UNITED STATES  
NUCLEAR REGULATORY COMMISSION  
OFFICE OF NUCLEAR REACTOR REGULATION  
WASHINGTON, DC 20555-0001

December 13, 2017

NRC INFORMATION NOTICE 2017-05, Revision 1: POTENTIAL BINDING OF SCHNEIDER  
ELECTRIC/SQUARE-D MASTERPACT  
NT AND NW 480-VAC CIRCUIT  
BREAKER ANTI-PUMP FEATURE

**Figure 1: The XF coil in the original logic is replaced by an XFCOM coil, which releases the close coil plunger as soon as the close signal is received, eliminating the potential for binding.**

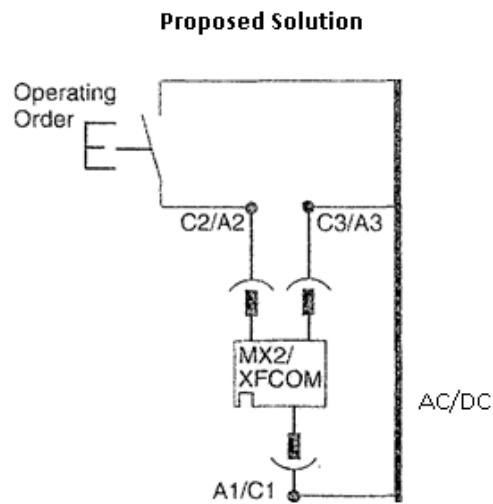
In Technical Bulletin TB-12-007, Revision 3, which is attached to the referenced 10 CFR Part 21 report (ADAMS Accession No. ML16278A471), AZZ/NLI provided a proposed modification to the breaker and an updated circuit diagram, shown in Figure 1 of this document. This modification replaces the normal XF (closing) coil in the breaker with an XFCOM coil. The XFCOM coil acts as a oneshot and releases the close coil plunger immediately after the close signal is applied to the breaker and will not reactivate the close coil plunger unless power is first removed from the operating order signal of the XFCOM and then re-applied. With the closing coil plunger retracted, this modification is designed to eliminate the potential for mechanical binding from the anti-pump feature.
